DOCUMENTS FOR REVIEW AND FILES LOCATION

Please charge time to 5600015- 102. Design Consultant response period: 12-22-2014 to 1-12-2015.

TOWN OF COLCHESTER COUNTY OF CHITTENDEN PROPOSED IMPROVEMENT SIDEWALK AND RESURFACING PROJECT STP 5600(15)

**CONCEPTUAL PLANS
NOVEMBER 24, 2014**

PROJECT NAME:	COLCHESTER
PROJECT NUMBER:	STP 5600(15)
FILE NAME:	Alignment Plans.dgn
PROJECT LEADER:	J. LEINWOHL
DESIGNED BY:	T. DUGUAY
FOR	EA ALIGNMENT PLAN AP-03
PLOT DATE:	11/24/2014
DRAWN BY:	T. DUGUAY
CHECKED BY:	J. LEINWOHL
SHEET	13 OF 35

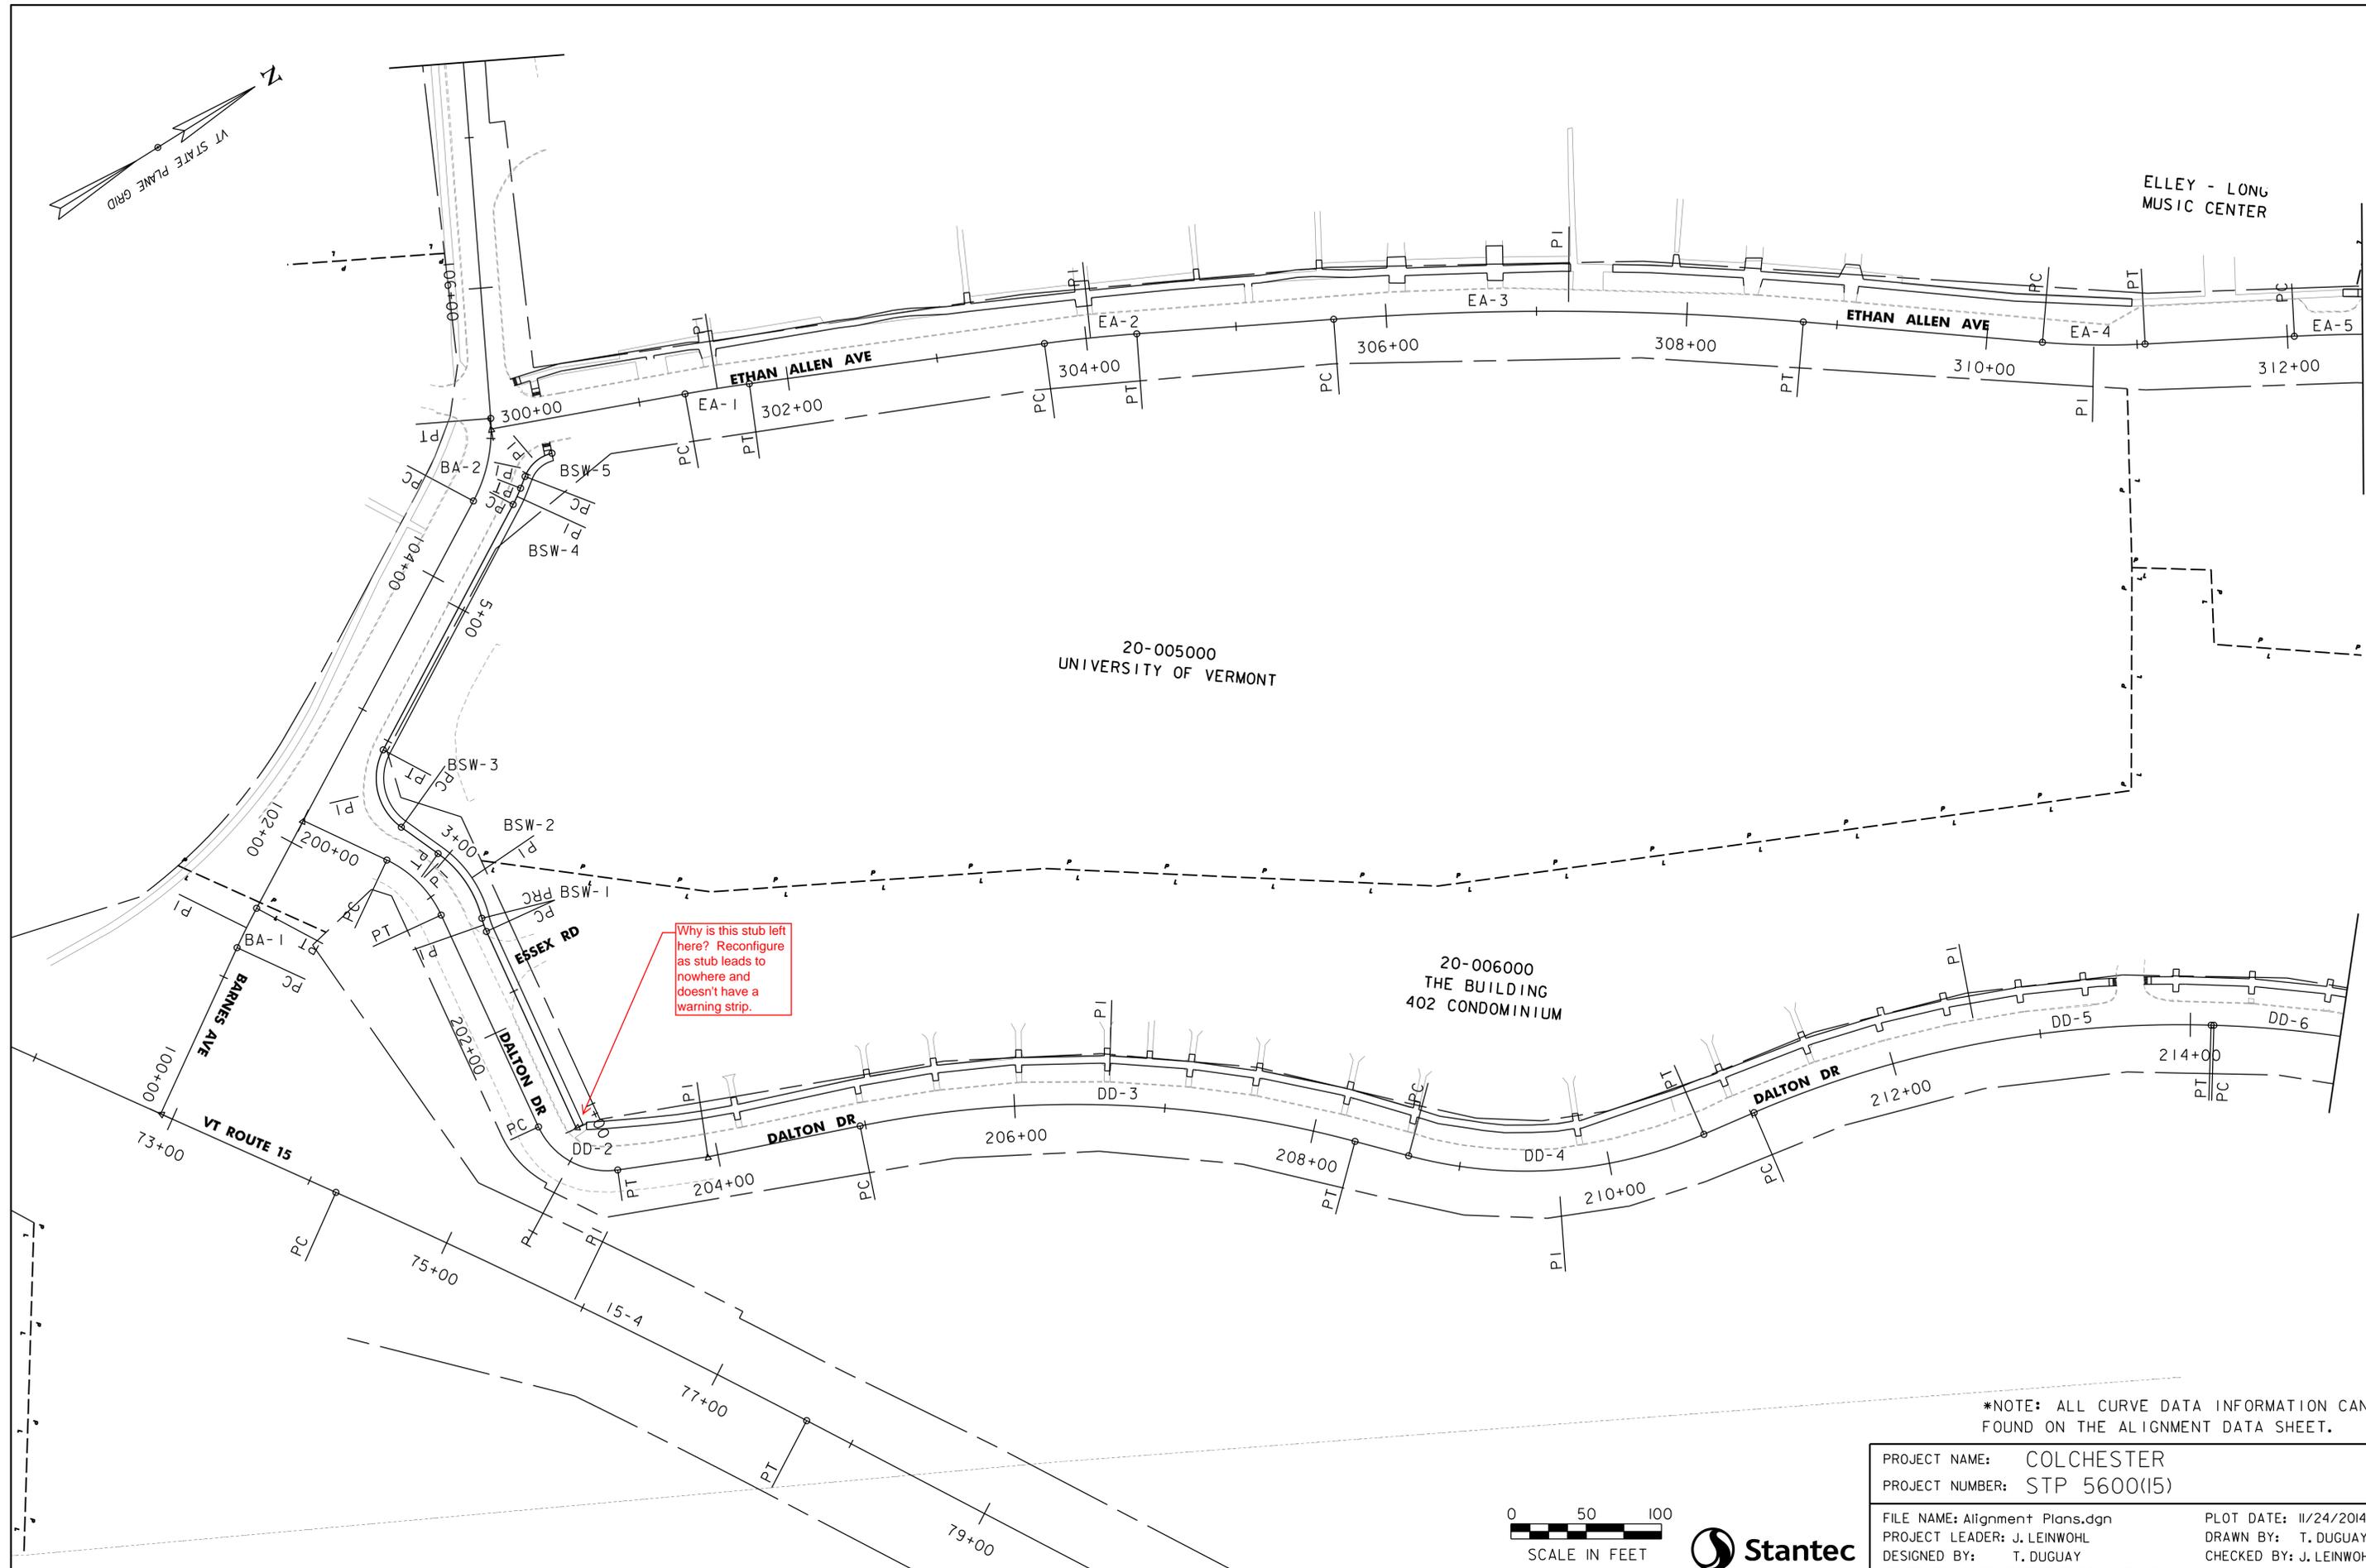
Why is this stub left here? Reconfigure as stub leads to nowhere and doesn't have a warning strip.

PROJECT NAME:	COLCHESTER
PROJECT NUMBER:	STP 5600(I5)
FILE NAME:	GeneralPlans_Route15.dgn
PROJECT LEADER:	J. LEINWOHL
DESIGNED BY:	T. DUGUAY
PLOT DATE:	11/24/2014
DRAWN BY:	T. DUGUAY
CHECKED BY:	J. LEINWOHL
<b>ROUTE 15 SIDEWALK PLAN &amp; SECT 02</b>	
SHEET 19 OF 35

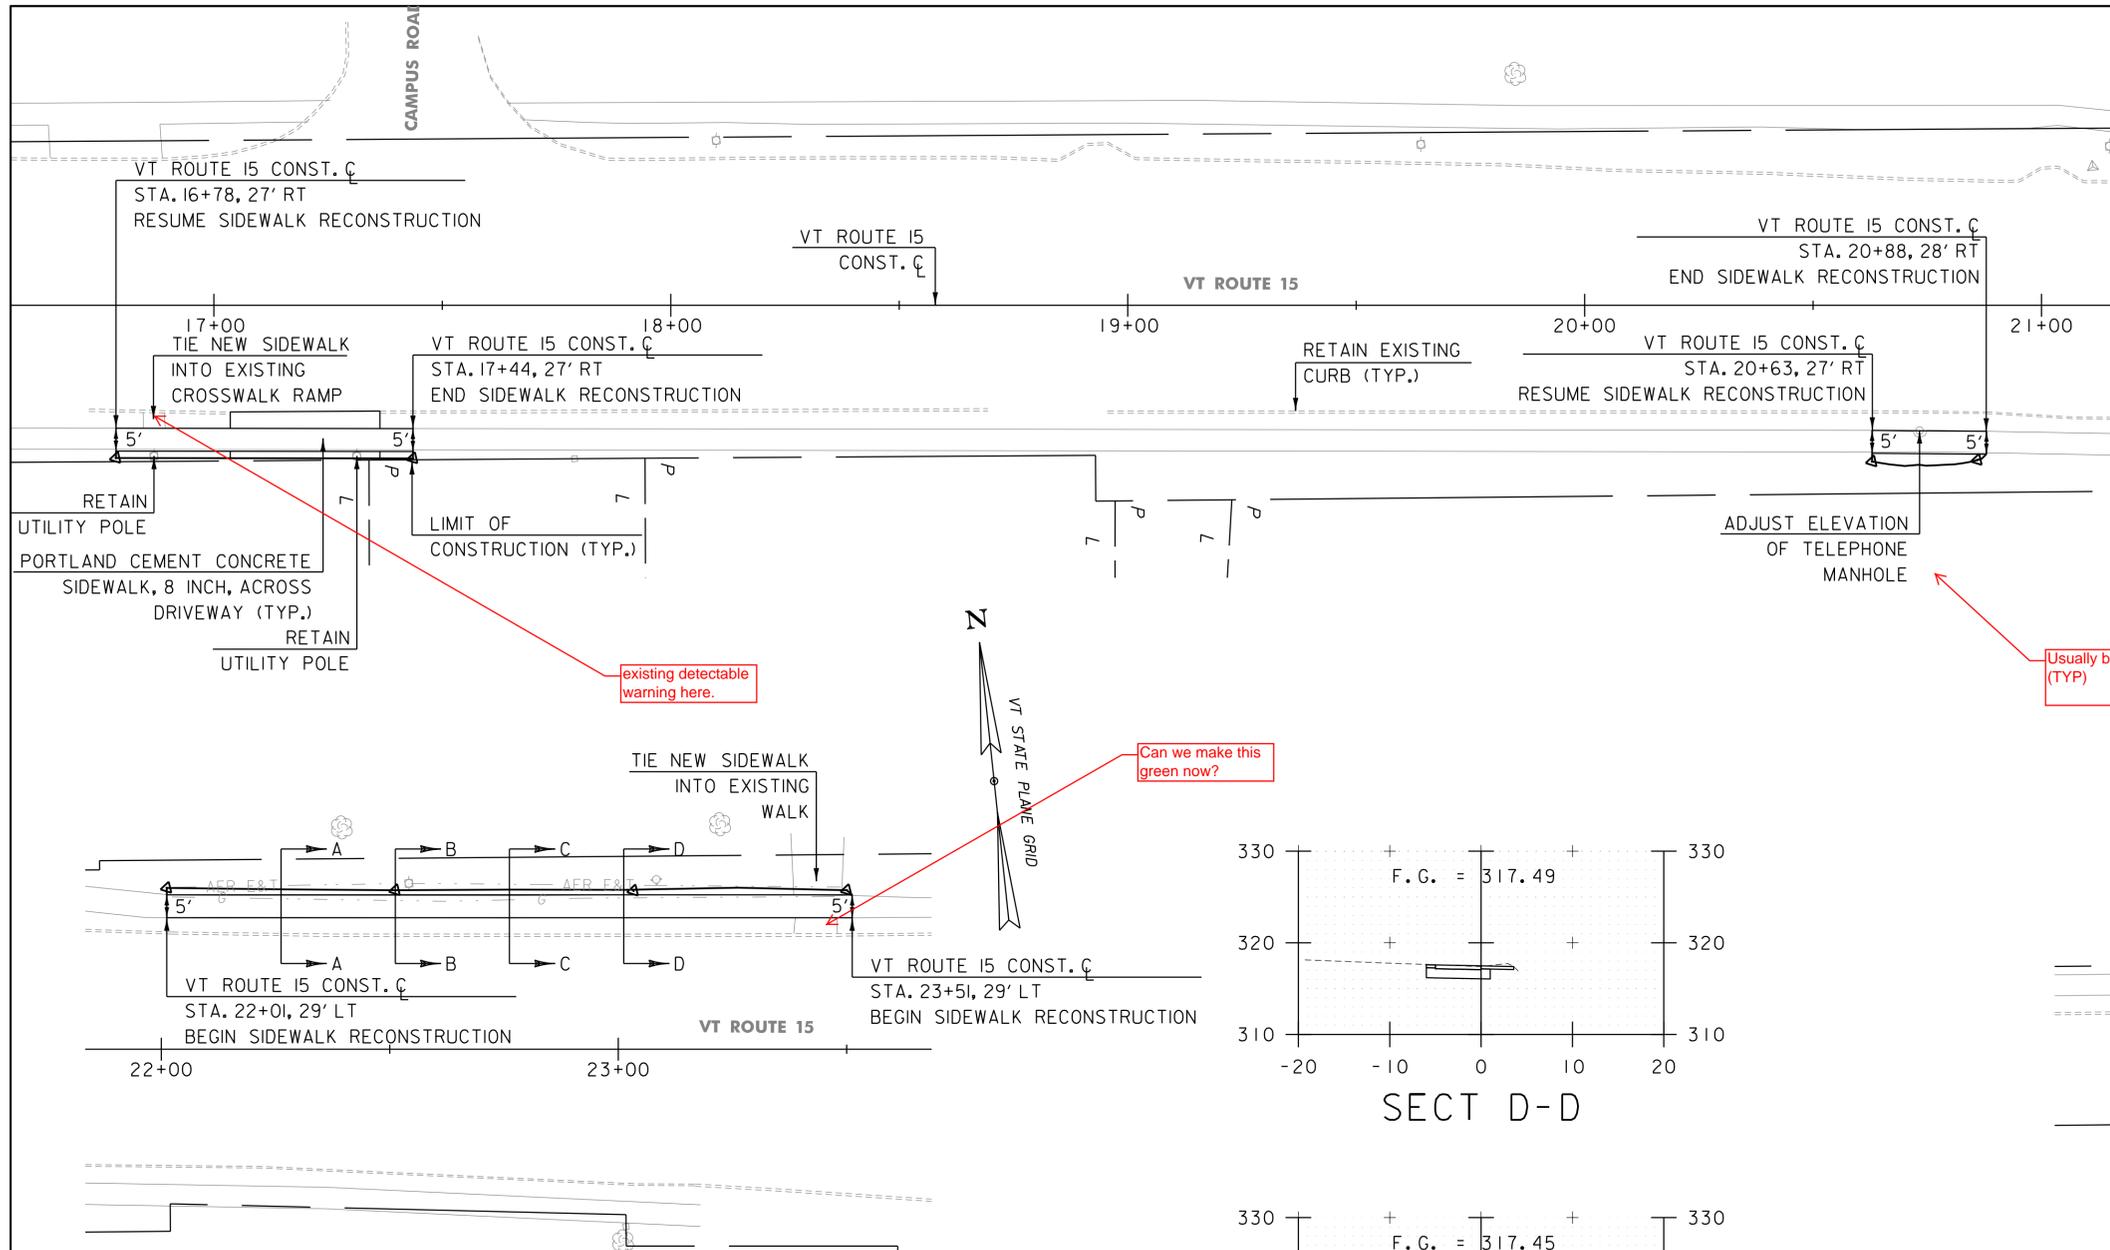
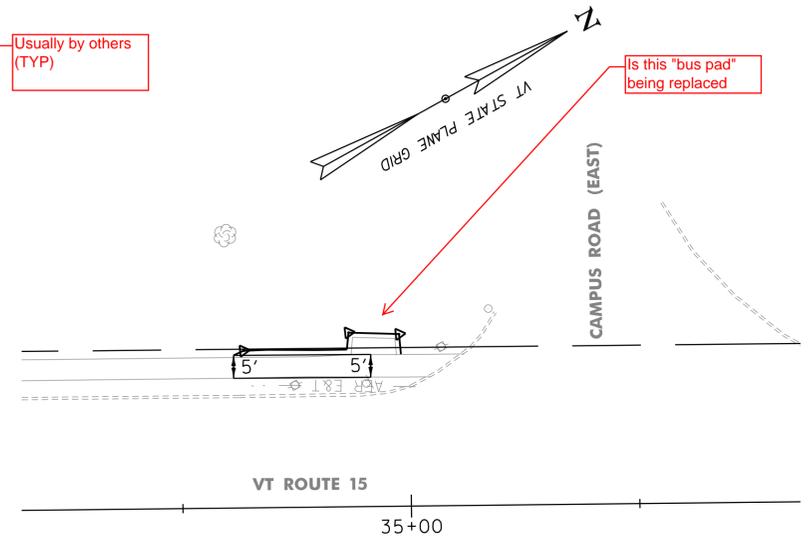
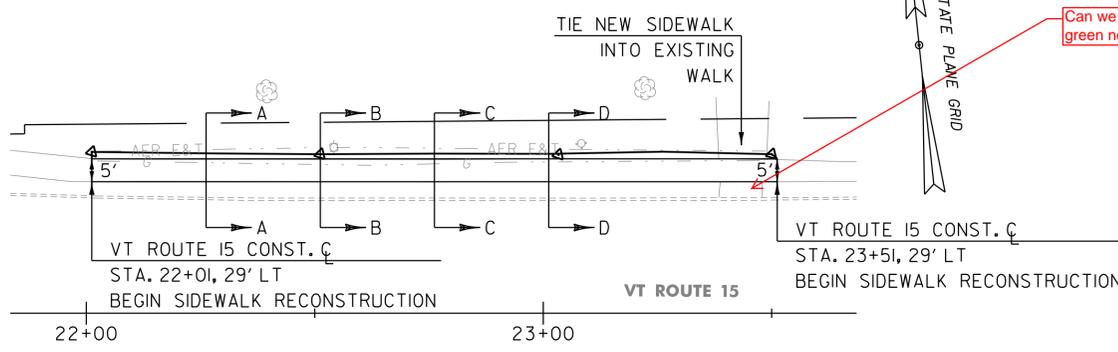
existing detectable warning here.

Usually by others (TYP)

Can we make this green now?

Is this "bus pad" being replaced

Contractor should also notify VTrans District 5 of all work near signals. (655-1580, Steve Guyette)

FILE NAME: General Plans_Route15.dgn PLOT DATE: 11/24/2014  
PROJECT LEADER: J. LEINWOHL DRAWN BY: T. DUGUAY  
DESIGNED BY: T. DUGUAY CHECKED BY: J. LEINWOHL  
ROUTE 15 SIDEWALK PLAN & SECT 04 SHEET 22 OF 35

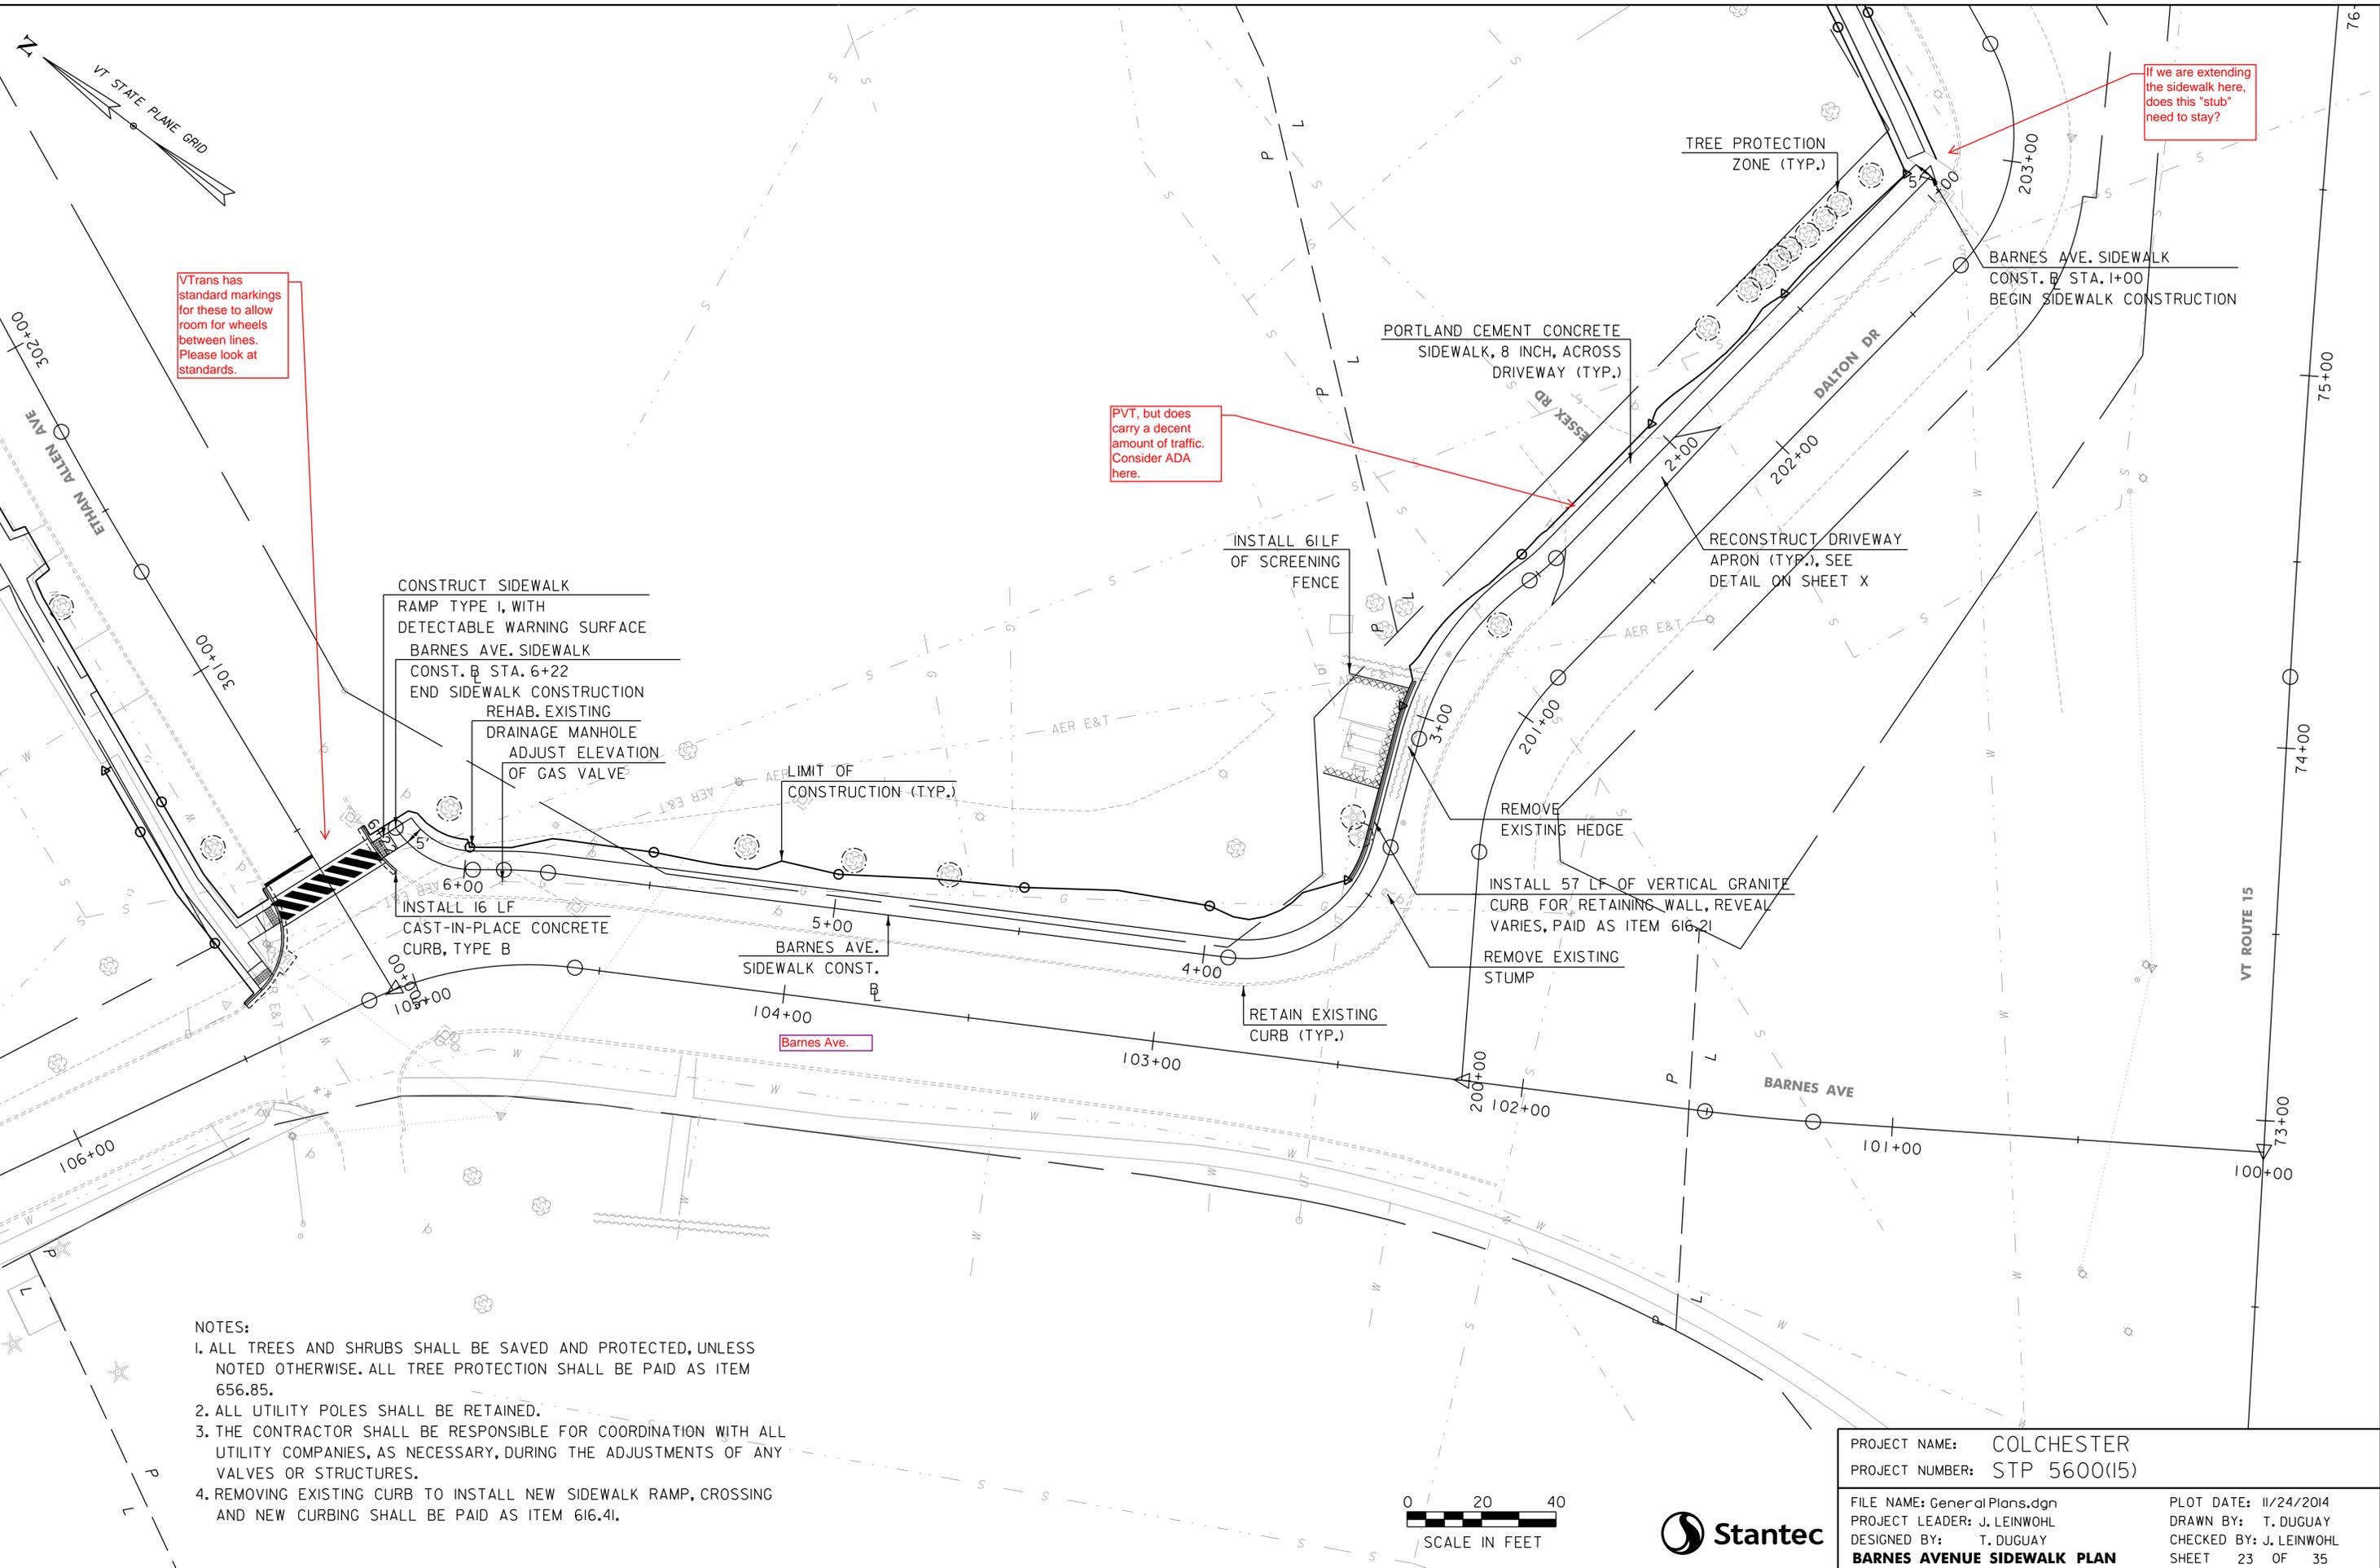
VTrans has standard markings for these to allow room for wheels between lines. Please look at standards.
